Access Compliance Report

Public Rights-of-Way

Intersection ID: 10032740	Main Street: N SHARON AMITY RD	Cross Street: N/A	Location: SE
ADA ID: F1AE509E73F2	Ramp Type: Perp	Initial Pass/Fail: Fail	Overall Compliance: No
Severity Score: 13.75			
Codes/Mitigation Info/Possible Solution		Field Measurements/Component Compliance

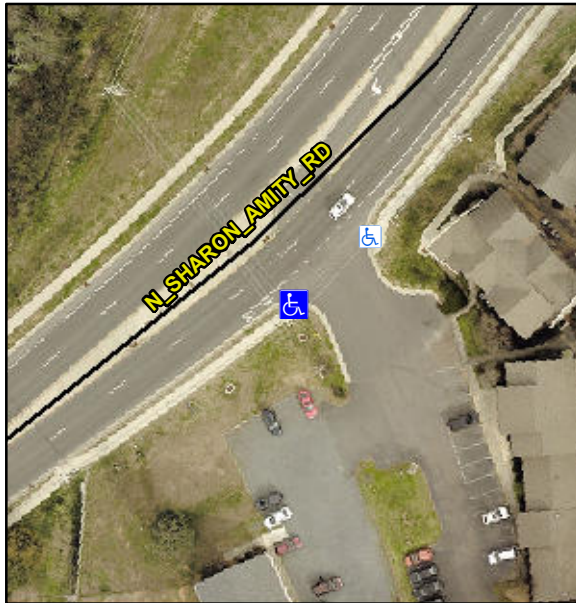
R304.2.2, R304.5.3

Compliance	Description	Data	Compliance	Description	Data
N/A	Ramp Length (in)	78.0	No	Ramp Slope (%)	9.3
Yes	Ramp Width (in)	58.5	No	Ramp XSlope (%)	3.7
N/A	Flare Type LT	N/A	N/A	Flare Type RT	N/A
N/A	Flare Slope LT (%)	N/A	N/A	Flare Slope RT (%)	N/A
N/A	Flare Traversable LT?	N/A	N/A	Flare Traversable RT?	N/A
N/A	Landing Length (in)	N/A	N/A	DWS Provided?	N/A
N/A	Landing Width (in)	N/A	N/A	DWS Contrast?	N/A
N/A	Landing Slope (%)	N/A	N/A	DWS Length (in)	N/A
N/A	Landing X Slope (%)	N/A	N/A	DWS Full Width?	N/A
N/A	Landing Curb? (Y/N)	N/A	N/A	DWS Offset (in)	N/A
N/A	Shared Landing?	N/A			
N/A	Gutter Ponding?	N/A	N/A	Gutter Slope (%)	N/A
N/A	Gutter Lip Ht (in)	N/A	N/A	Gutter X Slope (%)	N/A
N/A	Painted X Walk1?	No	N/A	Painted X Walk2?	N/A
	X Walk 1 Direction	To NE		X Walk 2 Direction	N/A
N/A	X Walk 1 Width (in)	N/A	N/A	X Walk 2 Width (in)	N/A
	X Walk 1 Slope (%)	0.8		X Walk 2 Slope (%)	N/A
	X Walk 1 X Slope (%)	2.1		X Walk 2 X Slope (%)	N/A

Remove & Replace Entire Ramp.
